Main Entrance and Laundry Room  
Accessibility Renovation  
725 Pleasant Street  
New Bedford, MA 02740  
Project No. 205267

**ADDENDUM NO. 1 08/01/2025**

**ADDENDUM NO. 1 ATTACHMENT**  
**August 1, 2025**

New Bedford Housing Authority  
Main Entrance and Laundry Room  
Accessibility Renovations at the  
Hotel Apartments (667-3)

**A** STOREFRONT ELEVATION - INNER DOOR

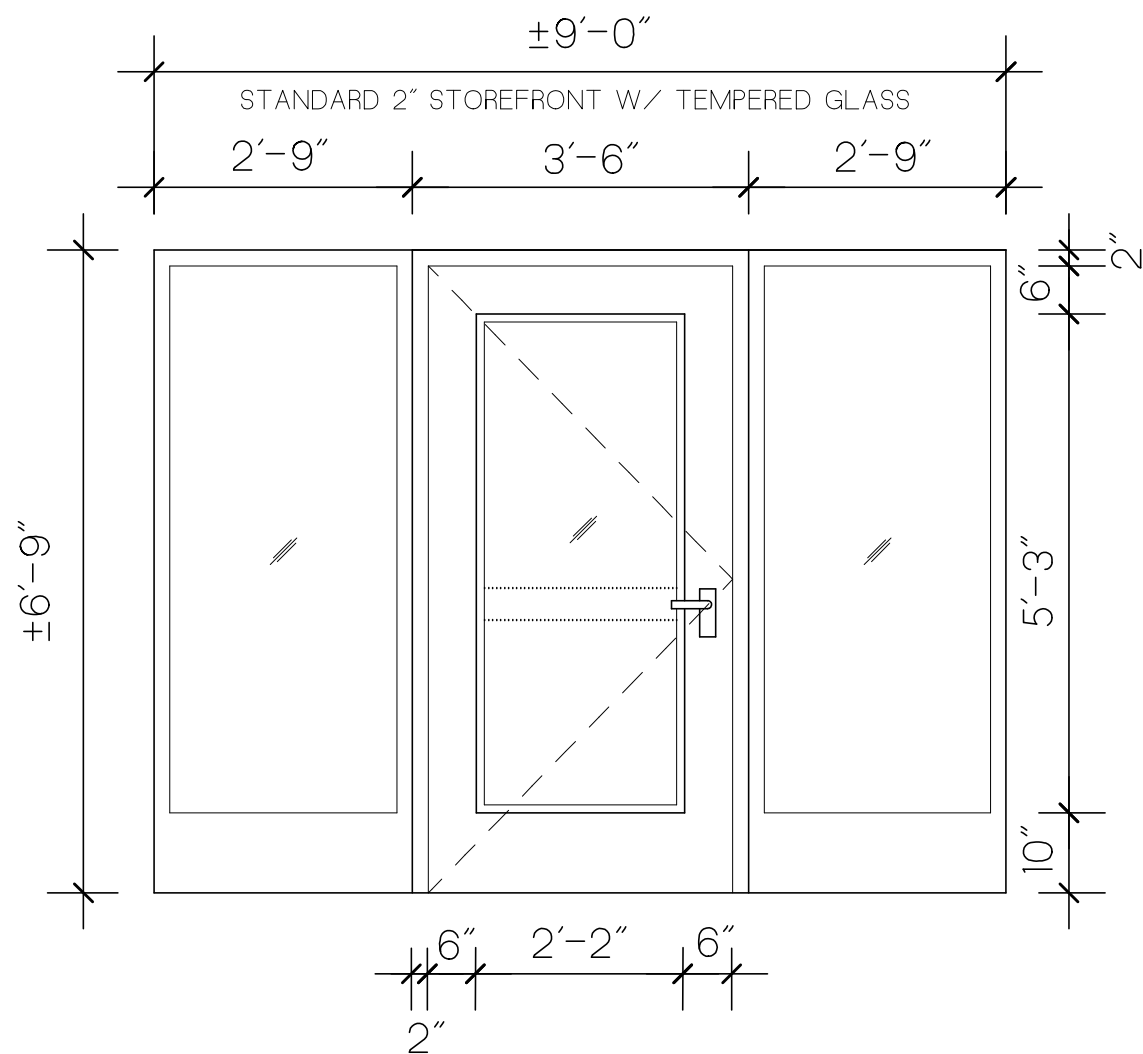
- 1.4 *Q: Is the hardware for the aluminum storefronts by the Metal Window FSB?*  
A: Please see the response to item 1.1 above.
- 1.5 *Q: Please provide an up-close elevation of the window within the new storefront. The grid of the window glass looks different 2/A2.1 and 3/A2.1. Need more accurate glass measurements for this window.*  
A: Please see SKA-1

- 1.6 *Q: Specifications list (3) different frame types as the basis of design. Which one is it? The design team needs to differentiate which frames are which system. Design team should also clearly depict the frames in elevation and which system they are expecting to get at each one.*  
A: Please also see the response above and SKA-1

- 1.7 *Q: Elevation shown for exterior upper frames shown muntins.*  
Please see SKA-1.
- 1.8 *Q: Please provide storefront elevations showing dimensions of the overall frames (width & height) as well as vertical and horizontal mullion spacing/locations.*  
A: Please see SKA-1.

IMPACT RESISTANT 2" STOREFRONT SYSTEM AT EXT.

**B** STOREFRONT ELEVATION-LEFT

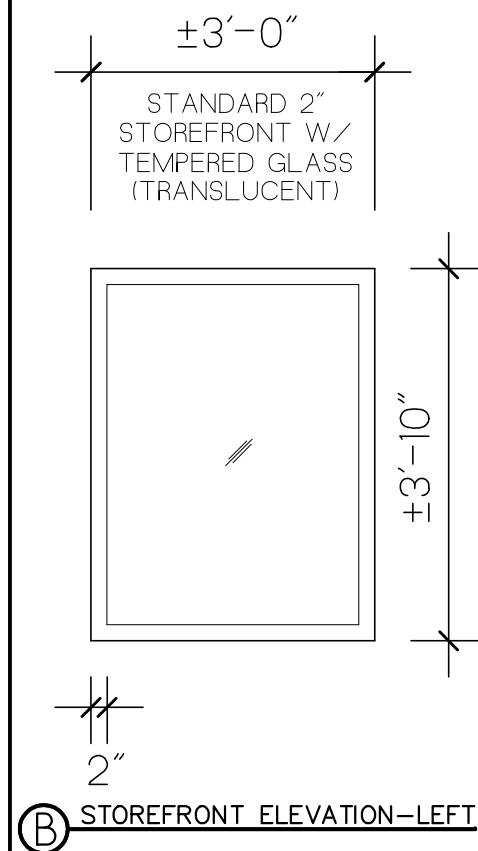
- 1.20 *Q: Translucent glass is detailed in section 088001 Glazing but there is none called out in the drawing. Please specify where translucent glass is to be installed.*  
A: The translucent glass shall be installed in the new storefront at the side of the new vestibule that is adjacent to the interior stair landing. SKA-1.

- 1.22 *Q: Spec Section 08 41 13 lists (4) different glass types (all impact resistant). Please advise which glass goes in which opening.*  
A: Please see the response to item 1.21 above and see SKA-1
